Carroll, Iowa

TRAFFIC SAFETY STUDY

HENNINGSON, DURHAM & RICHARDSON

PRELIMINARY

figure 10

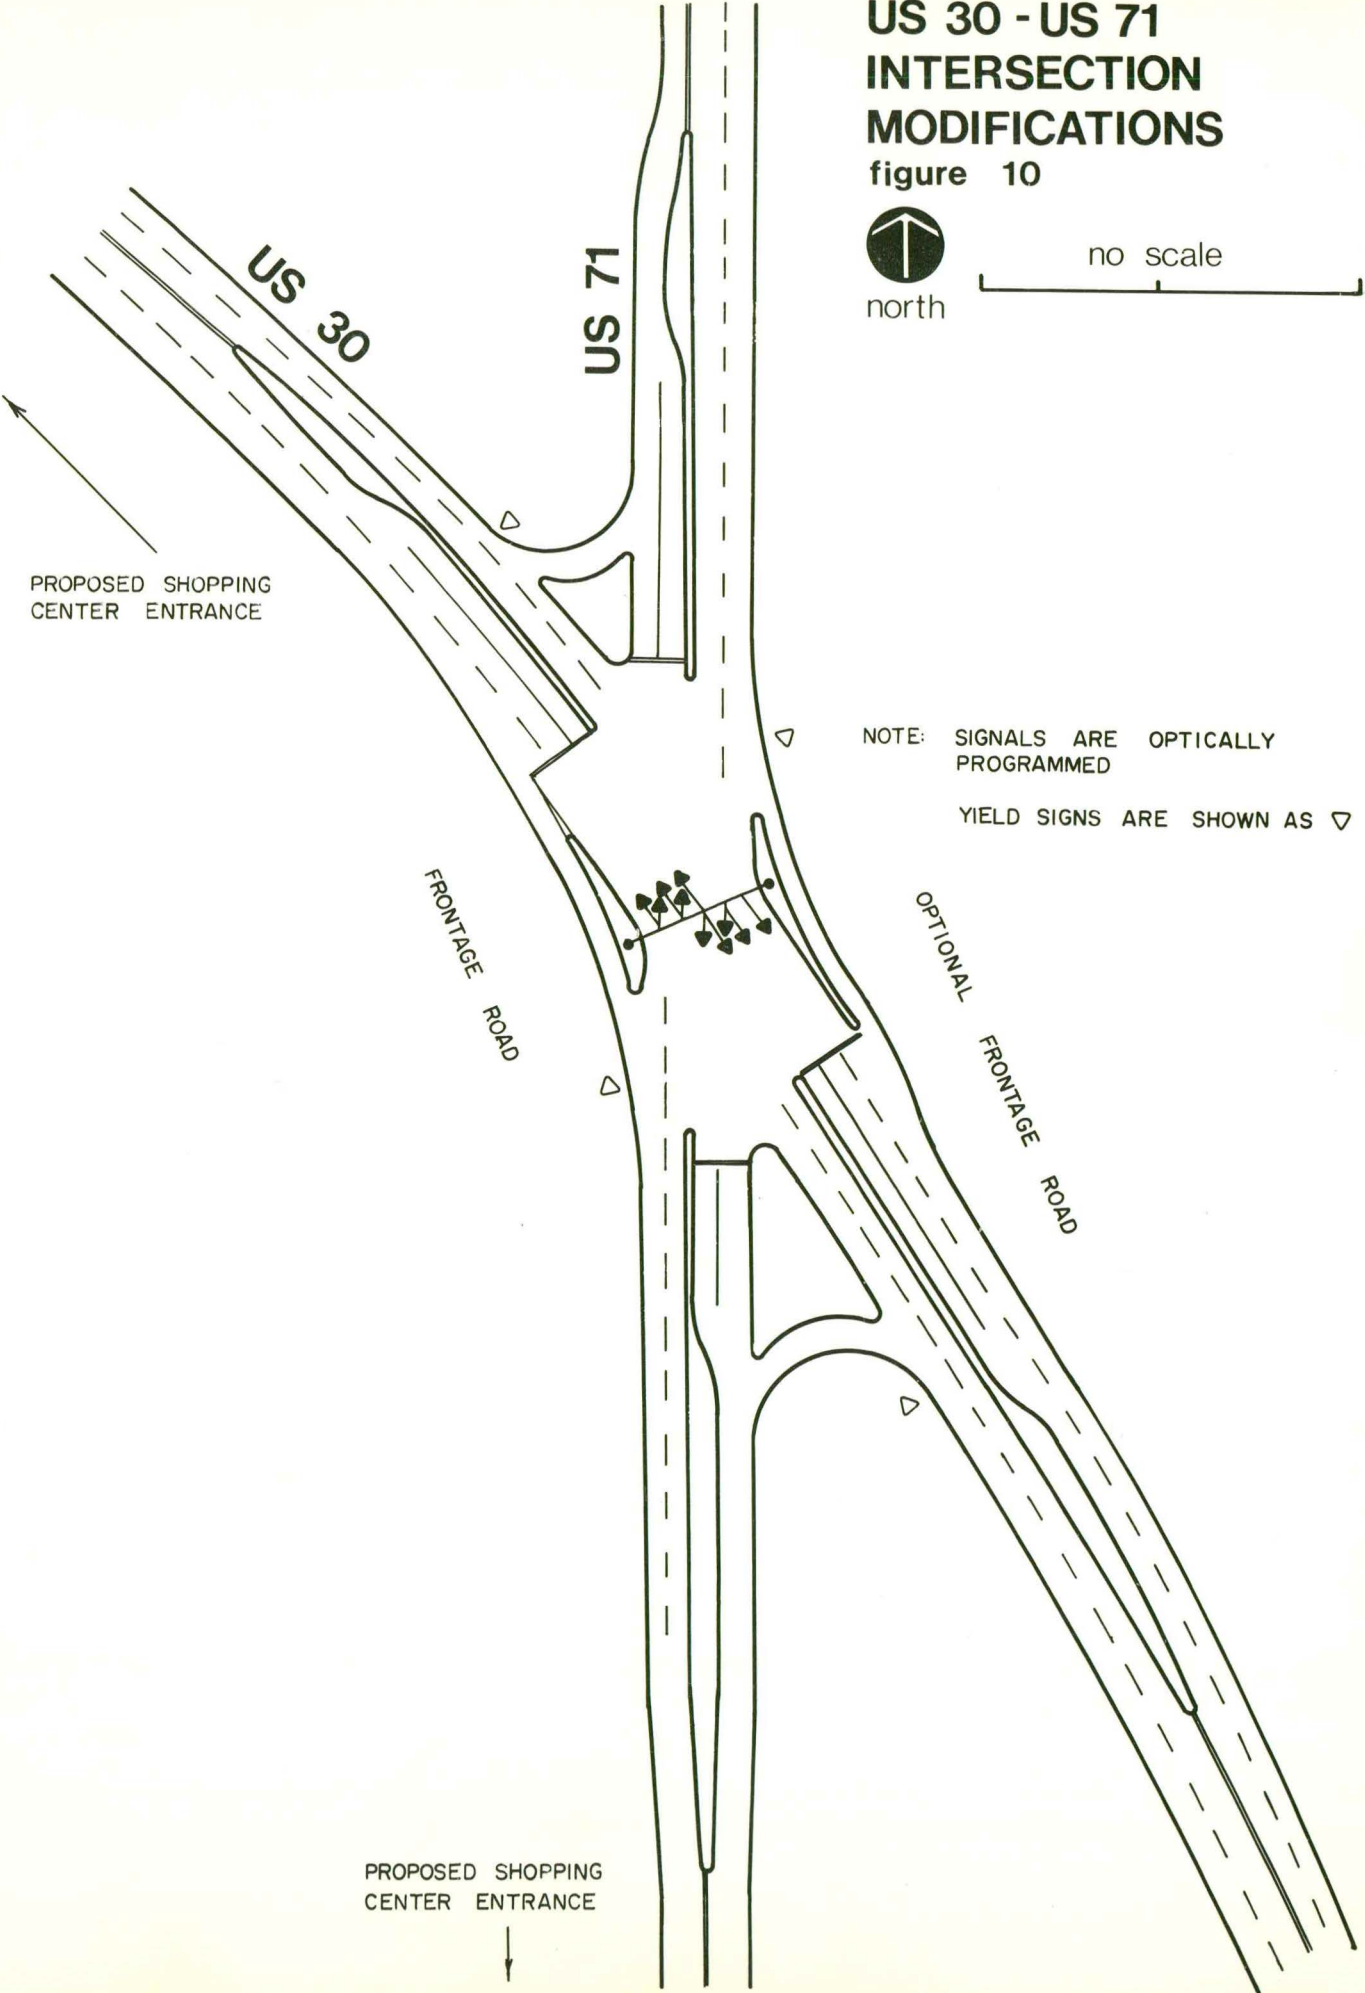
Show proposal of US 71 & 30 design

INTERIM SOLUTION US 30-US 71 INTERCHANGE figure 11

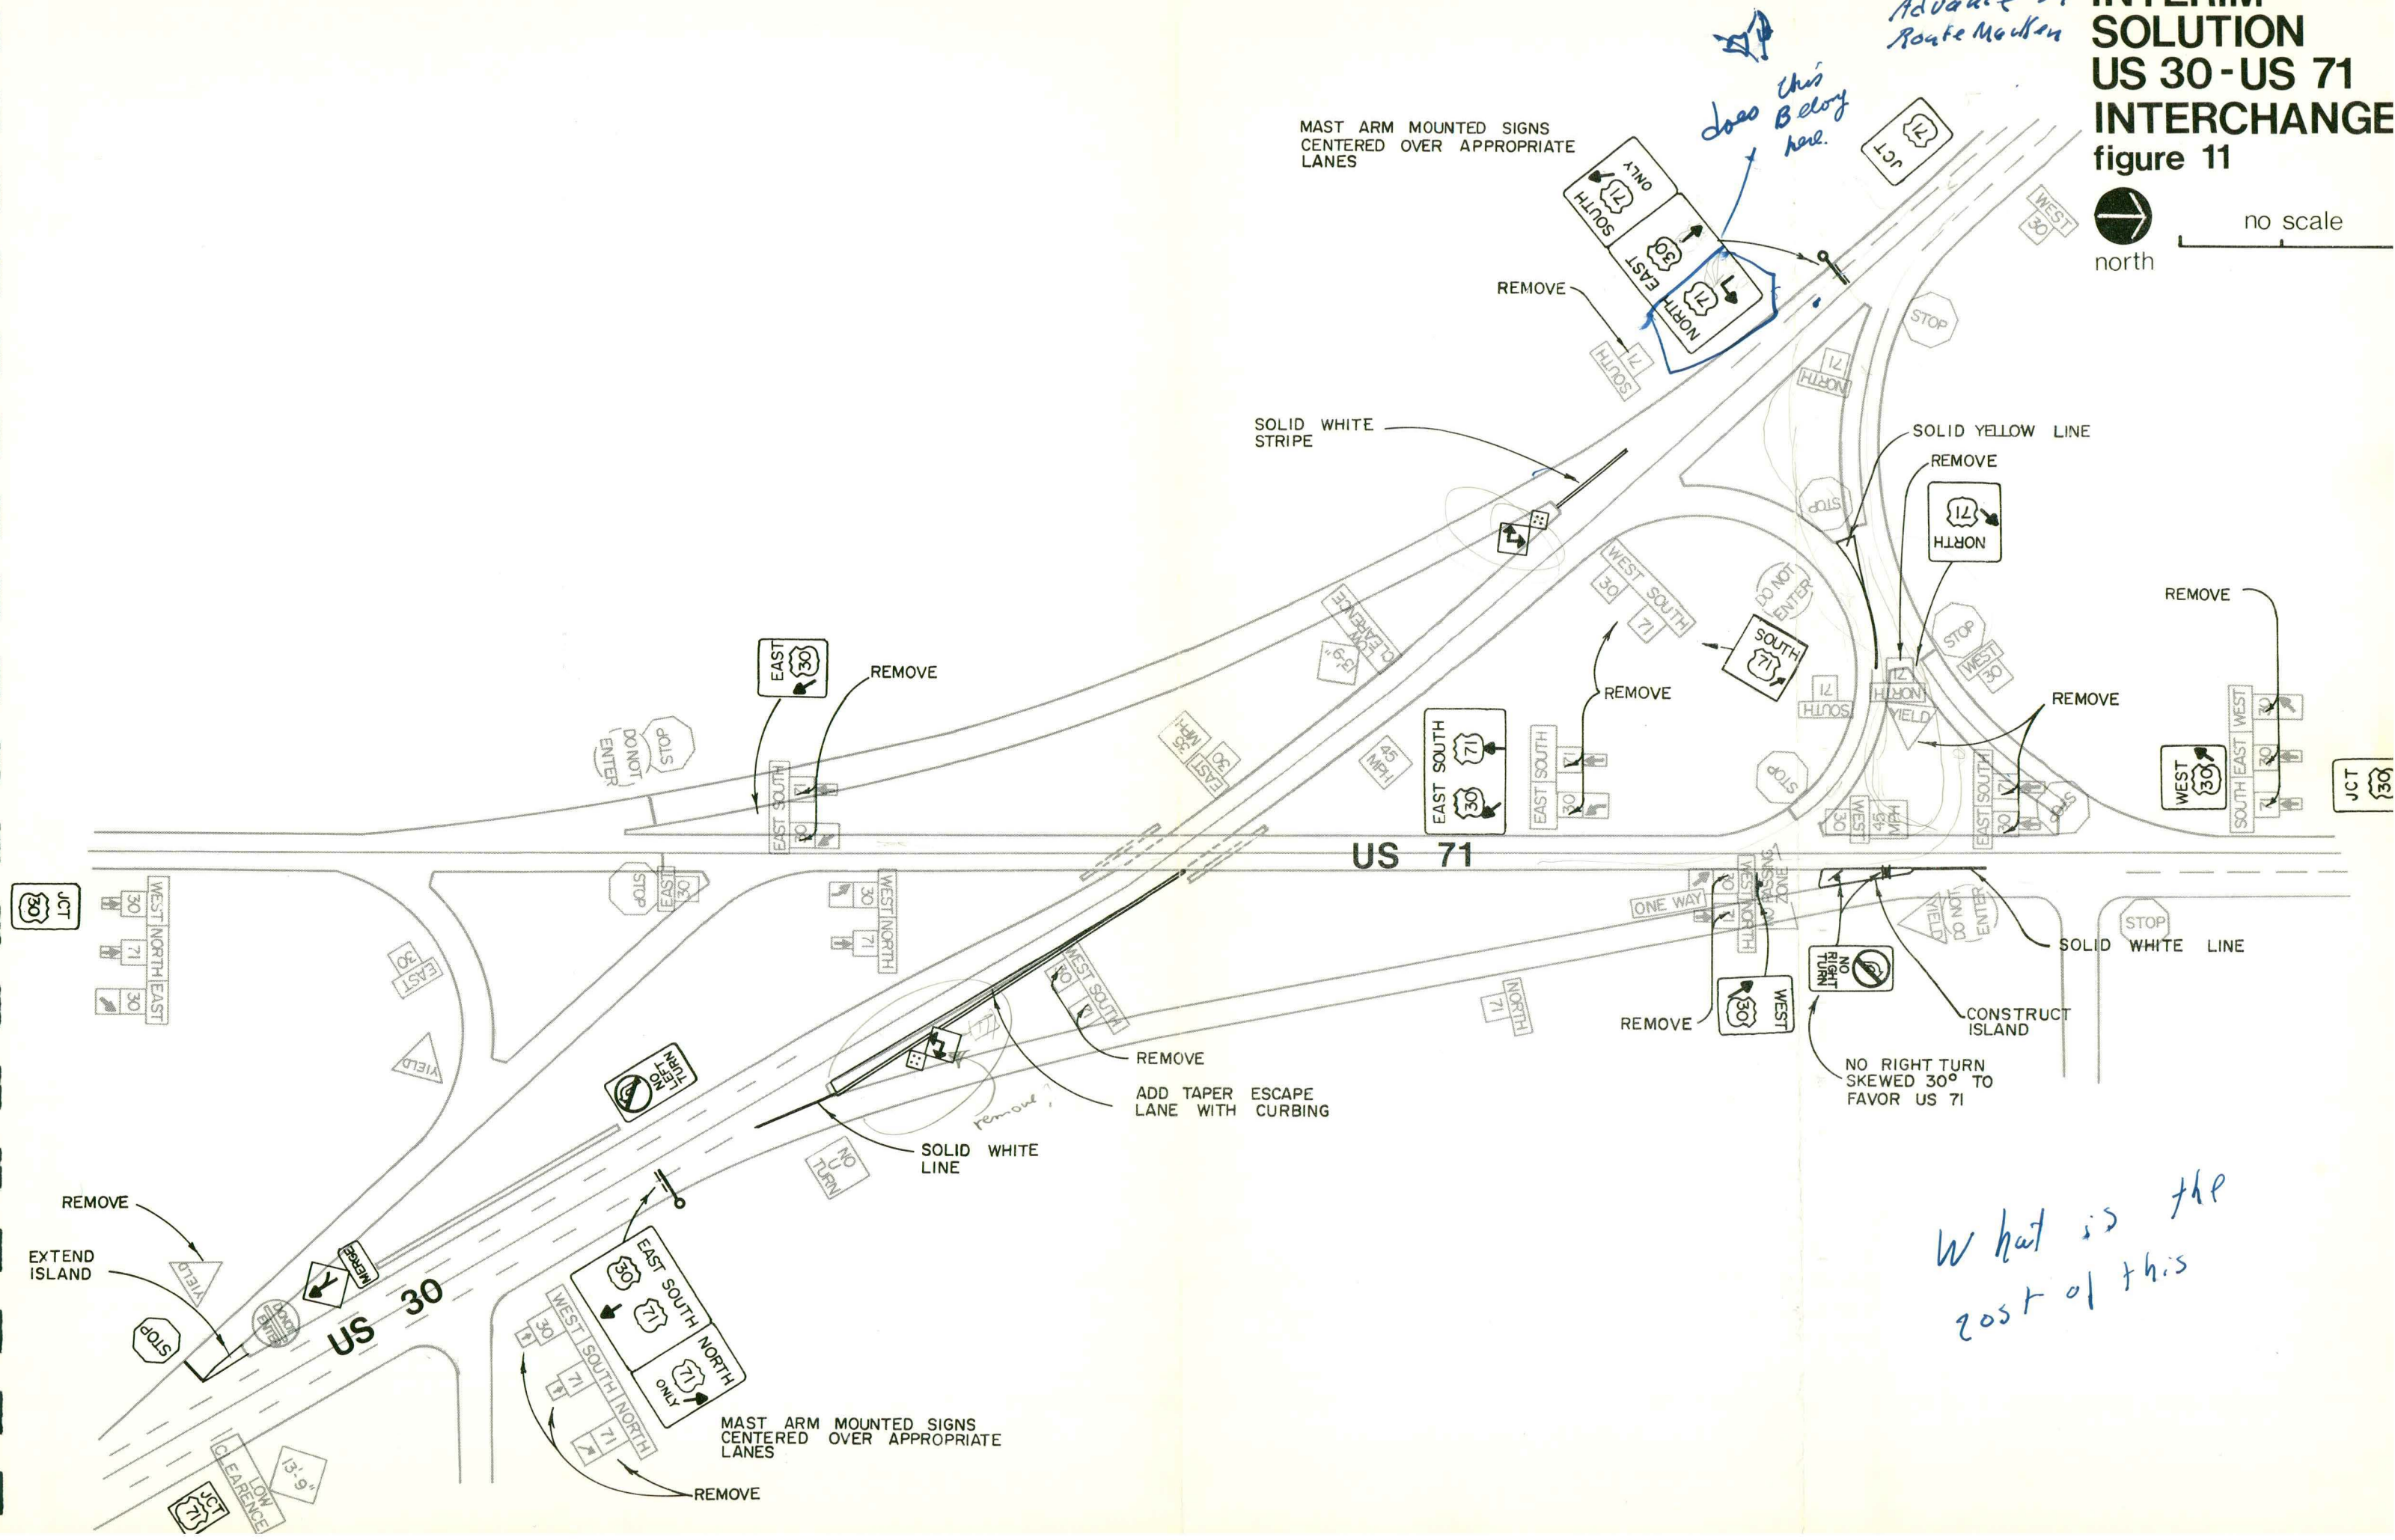
Does this belong here.

?
